**SENIOR LIVING URBAN (EPSOM) LTD
GUILD LIVING CARE COMMUNITY
EPSOM HOSPITAL
WOODCOTE GREEN ROAD**

**STAGE 1 ROAD SAFETY AUDIT
RESPONSE REPORT**

Project Code:	GLEpsom.1
Prepared by:	RG
Approved by:	RG
Issue Date:	May 2020
Status:	Final

APPENDIX B: Revised Layout Drawing

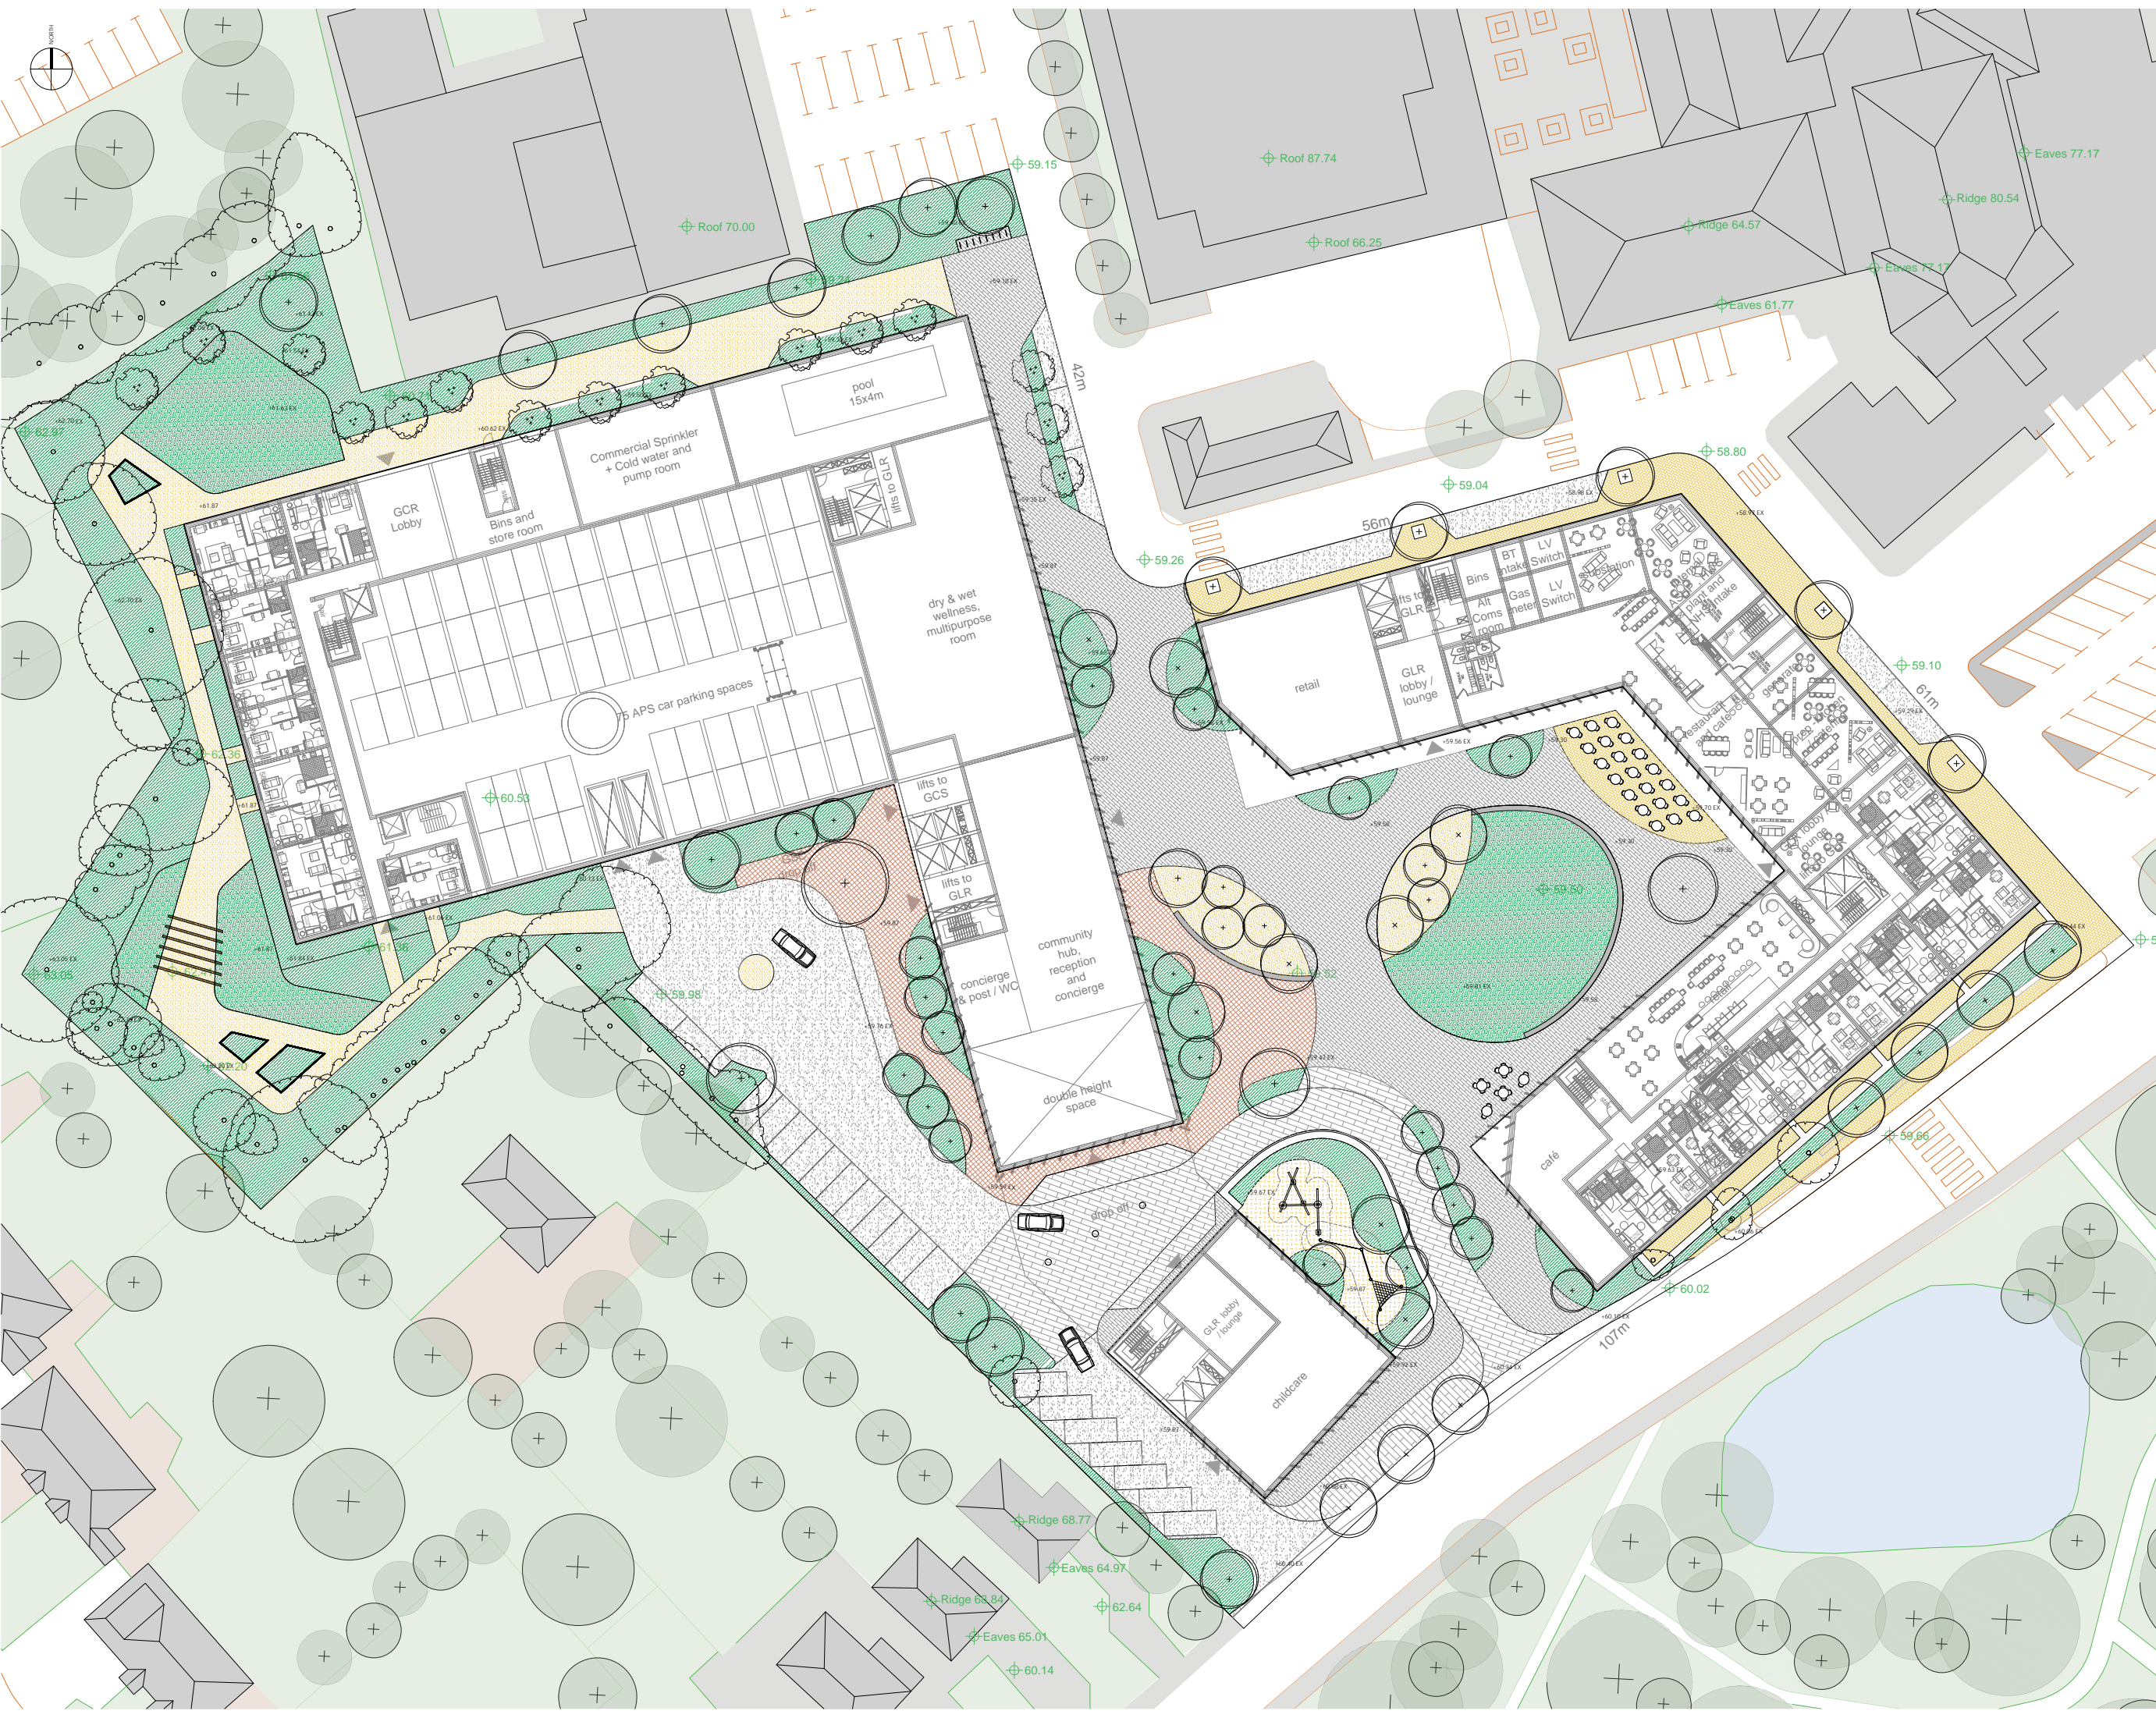
Location: Site frontage/Rear edge of footway between the proposed vehicular ingress and egress (please refer to reference point 3.4 in **Appendix B**)

The recirculation lane provided within the development site abuts the rear edge of footway between the vehicular ingress and egress. The Audit Team are concerned, that without some form of physical measures being provided, vehicles turning right into the recirculation lane could over run the footway, and potential strike pedestrians using the footway. Conversely, without some form of physical measure being provided, pedestrians using the footway may inadvertently stray off the footway and onto the recirculation lane, and subsequently being at risk of being struck by a moving vehicle.

It is recommended that some form of pedestrian restraint barrier and full height kerb is provided at the rear edge of footway/site boundary. It will be important to ensure that any pedestrian restraint barrier does not obstruction junction visibility splays.

Location: Woodcote Green Road/Proposed vehicular ingress and egress (please refer to reference points 3.5 in **Appendix B**)

The full height kerbed radii provided at both the site ingress and egress tie into the rear edge of the existing footway on Woodcote Green Road. This could result in vehicles following the kerb alignment and entering the footway, potentially leading to pedestrian/vehicle collisions.

It is recommended that if a bell mouth junction arrangement is to be provided, then the kerbed radii should tie into the channel line of Woodcote Green Road.

Location: Woodcote Green Road/Proposed vehicular ingress and egress (please refer to reference points 3.6 in **Appendix B**)

However, the proposed access arrangements include the provision of full height kerbed radii at both access points. This conventional bell-mouth type arrangement may indicate that vehicles accessing the site have priority over crossing pedestrians, this could result in confusion, driver hesitation and/or pedestrian being struck by a moving vehicle. Additionally, lack of provision of tactile paving at dropped crossing points on either side of the vehicle

It is recommended that both the ingress and egress are formed of a crossover arrangement including dropped kerbs.

Location: Site frontage/Rear edge of footway between the proposed vehicular ingress and egress (please refer to reference point 3.7 in **Appendix B**)

A number of trees are shown along the site frontage, one of which appears to be within the junction visibility splays, or if not within the visibility splays then very close to them. Even if the trees are intended to be of relatively small girth and have clear stems, they will inevitably have some impact on sightlines; this effect will be greater the closer they are to the egress and will increase with time as the trees grow. This will increase the risks of vehicles emerging from the egress and being struck by passing traffic.

- i. Provide visibility splays in accordance with relevant design standards and ensure that the splays will be kept free from obstruction.
- ii. Any vegetation within the splays should be maintained to ensure that it does not extend beyond a vertical height of 0.6m.
- iii. Do not plant trees within the visibility splays.

Location: Proposed vehicular ingress and egress (please refer to reference points 3.8 in **Appendix B**)

It will be important to provide appropriate signing and road markings to ensure that road users are able to differentiate between the vehicular ingress and egress, in order to reduce the risk of sudden braking and/or late turning manoeuvres.

It is recommended that appropriate 'No Entry' signing and 'No Entry' markings should be provided at the site egress to ensure vehicles are prohibited from turning into the site egress.

It is also recommended that appropriate 'Entry' signing, and 'Entry' or 'One Way' markings should be provided within the site ingress to ensure vehicles enter the site using the appropriate access point.

Agreed. A form of physical barrier between the vehicular route and footway will be provided in this location, most likely through the provision of additional landscaping/planters between the trees currently shown. This barrier will be illustrated on future layout plans.

*Agreed. This has been amended and is illustrated on the updated proposed site layout plan attached to this report at **Appendix B**.*

*Agreed. This arrangement is indicated on the updated proposed site layout plan attached to this report at **Appendix B**.*

Agreed. The proposed site layout will be reviewed, and any obstructions removed from the visibility splay in accordance with the above recommendations.

Agreed. Appropriate markings will be provided at the site ingress and egress in accordance with the above recommendation.
